SUBJECT: Request for Comments on the Proposed First Edition of the Standard for Positive Pressure Fire Tests of Door Assemblies, UL 10C; PROPOSED EFFECTIVE DATE

This bulletin proposes the first edition of the Standard for Positive Pressure Fire Tests of Door Assemblies, UL 10C.

PROPOSED FIRST EDITION OF THE STANDARD FOR POSITIVE PRESSURE FIRE TESTS OF DOOR ASSEMBLIES, UL 10C

FEBRUARY 1996 DRAFT

Figure 3.1

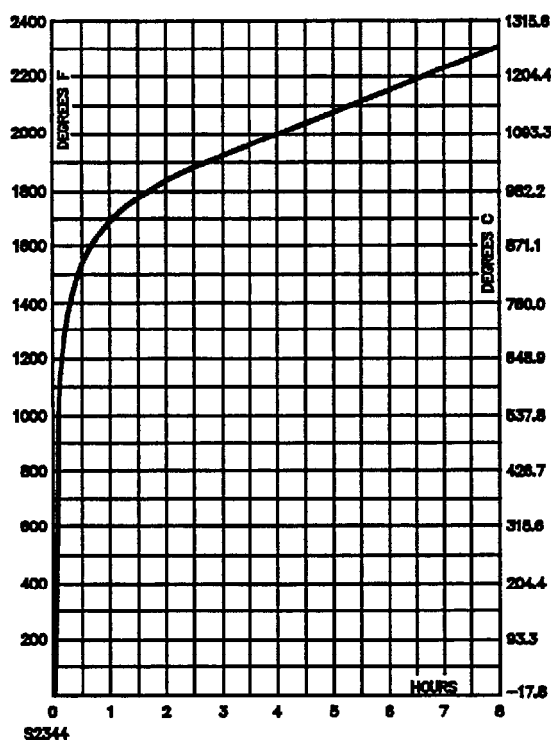
3.4.1.1 The fire exposure of door assemblies shall be controlled to conform to the applicable portion of the standard time-temperature curve shown in Figure 3.1 Appendix A. The points on the curve that determine its character are:

(DELETED)

Figure 4.5.1
Test furnace

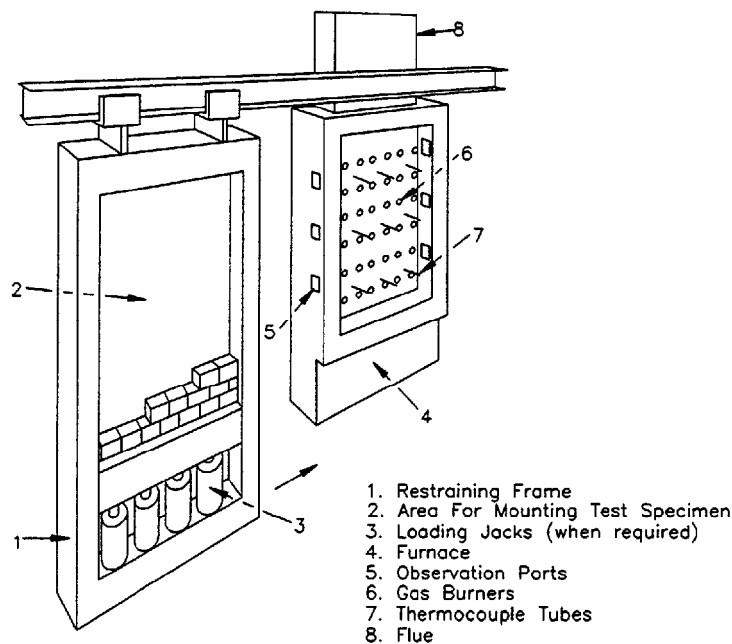
4.5.1 The temperatures of the test exposure shall be deemed to be the average temperature obtained from the readings of not less than nine thermocouples symmetrically disposed and distributed to show the temperature near all parts of the test assembly, see Figure 4.5.1. The thermocouples shall be protected by sealed porcelain tube having 3/4 inch (19.1 mm) outside diameter and 1/8 inch (3.2 mm) wall thickness or, as an alternate, in the case of base-metal thermocouples, protected by 1/2 inch (12.7 mm) wrought-steel or wrought-iron pipe of standard weight.
